**Project Name: UNIVERSITY OF CALIFORNIA, MERCED
HOUSING 4: THE SUMMITS
BID RELEASE 1**

Project No.: 906270

ADDENDUM NO. 2
to the
CONTRACT DOCUMENTS
OCTOBER 13, 2011

C4.1-R1

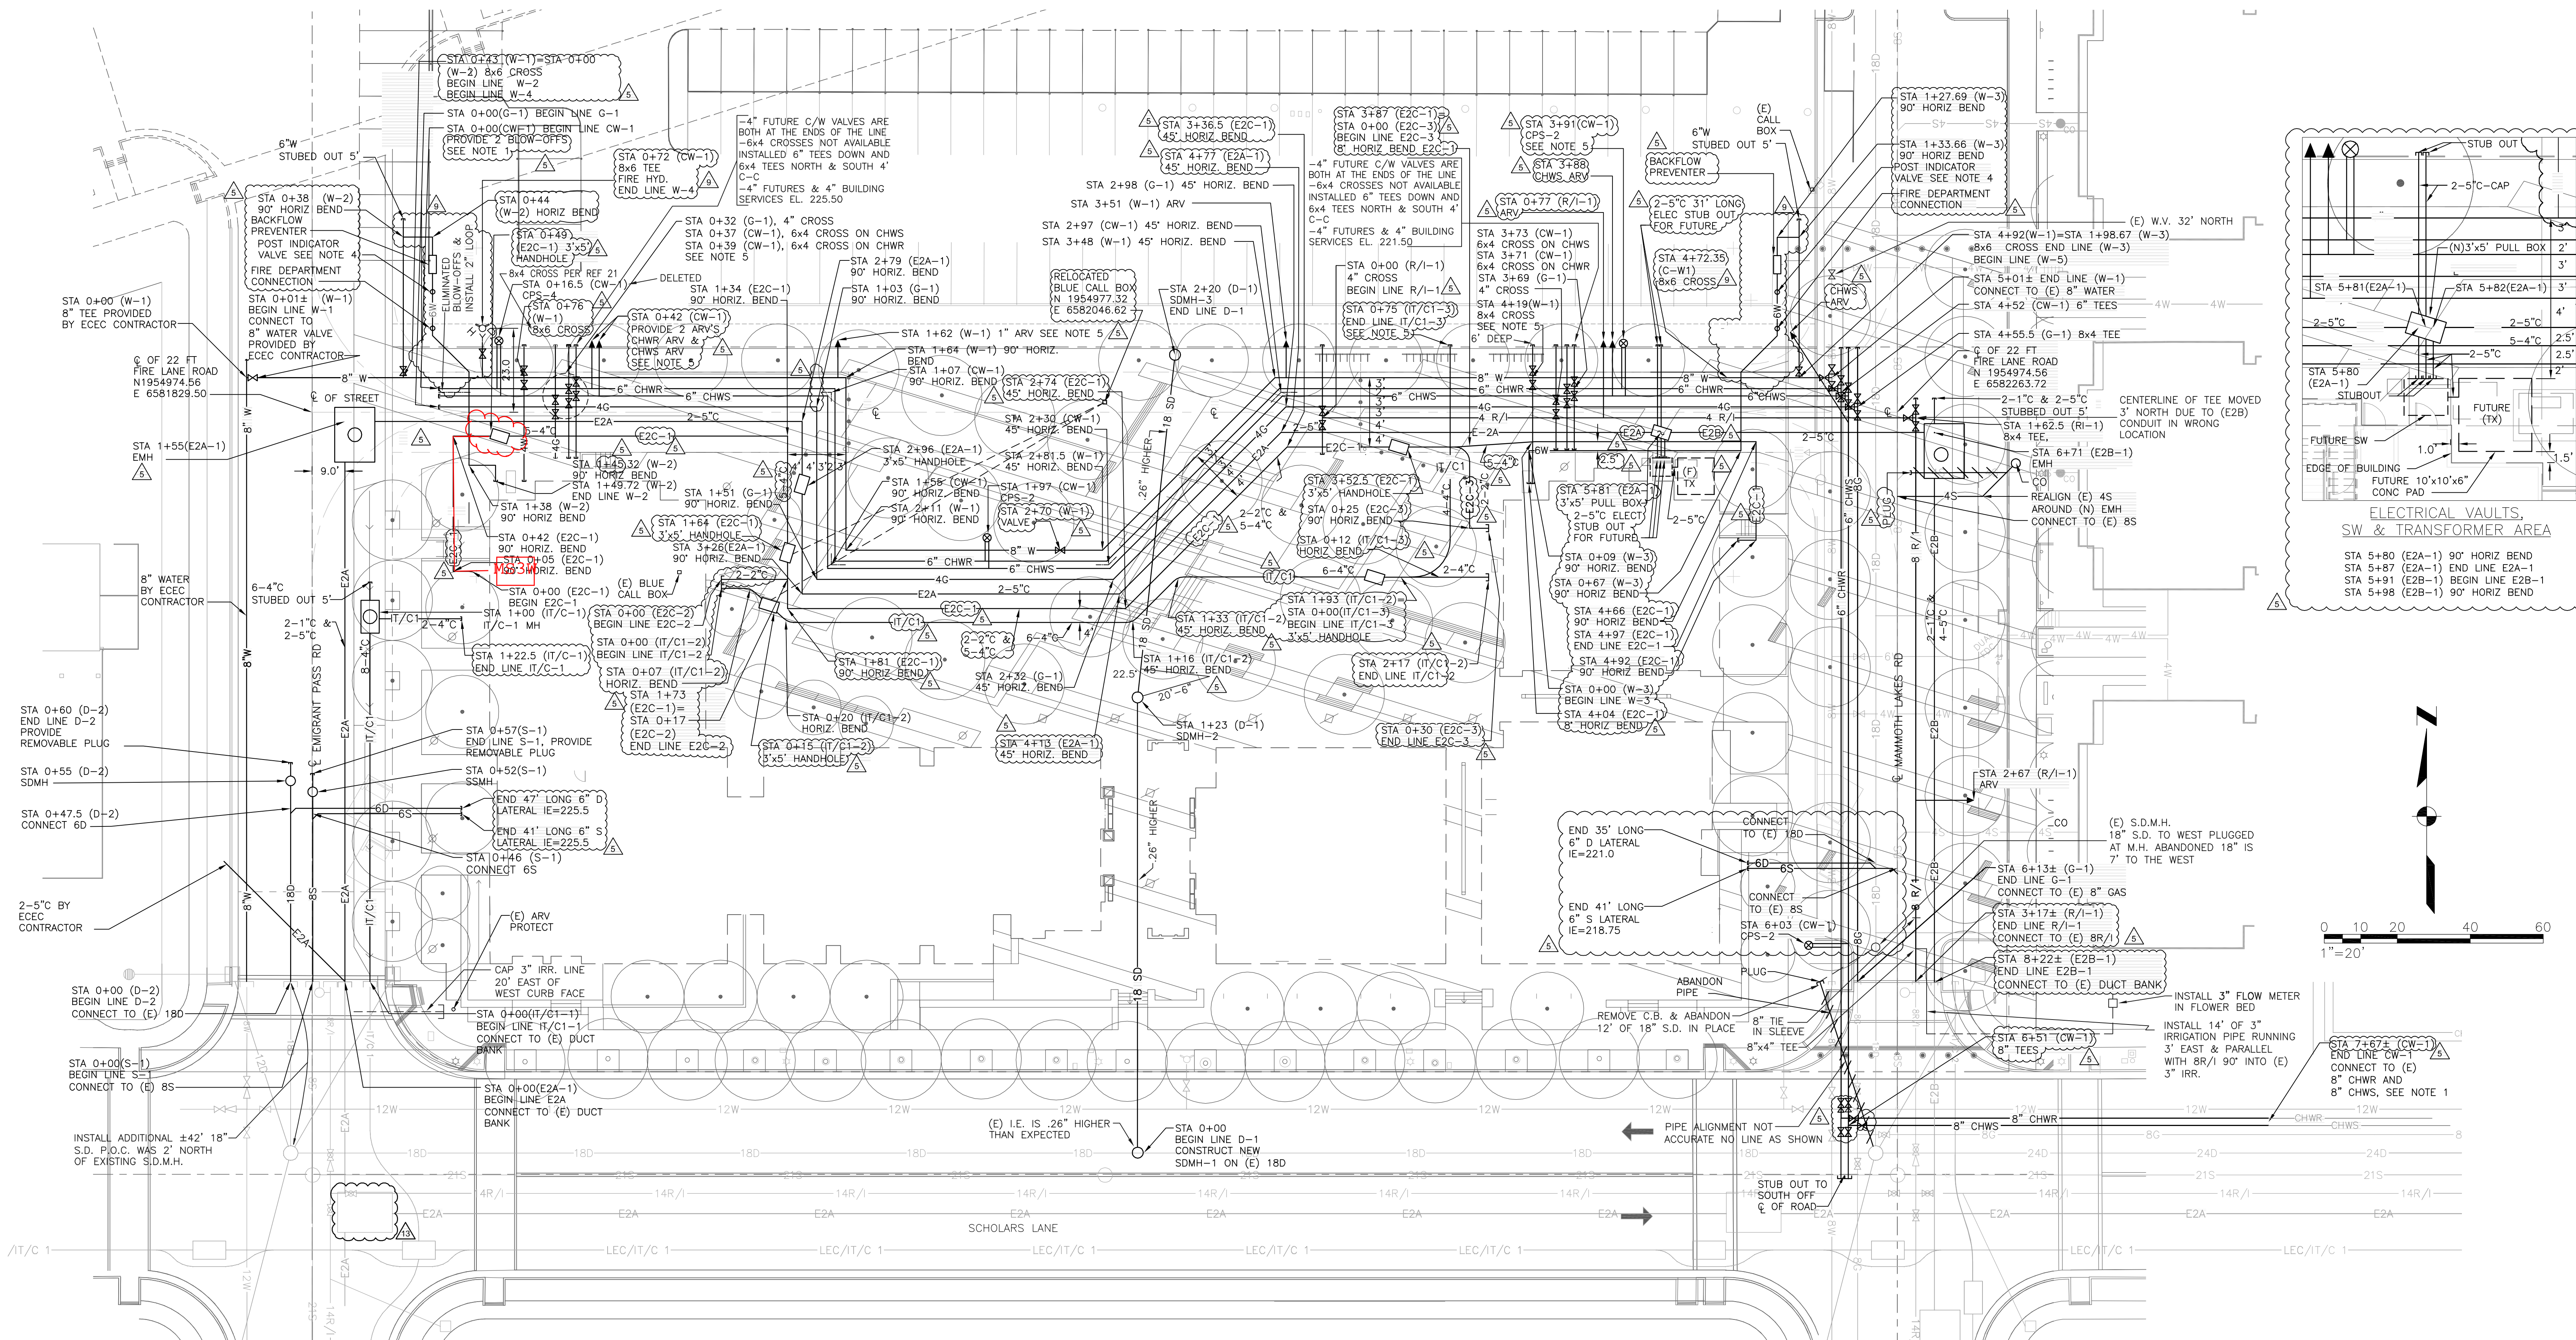
3. Q. Please clarify the point of connection location (of existing conduit or power panel MS3W) on CM1.0 (left hand side of the drawing) for the (3) 4" conduit & feeders for the temporary power.

- A. **ADD** Drawing C4.1 – R1 Marked Addendum #2. This is a marked up as-built drawing from Phase 3 Housing.

- A. Connect into existing 3 X 5 Handhole (EC2-1) Sta 0+49 shown on attached as-built drawing C4.1-R1 from Phase 3 Housing. Use spare conduits back to MS3W located in the Phase 3 Building against the exterior wall adjacent to Emigrant Pass.
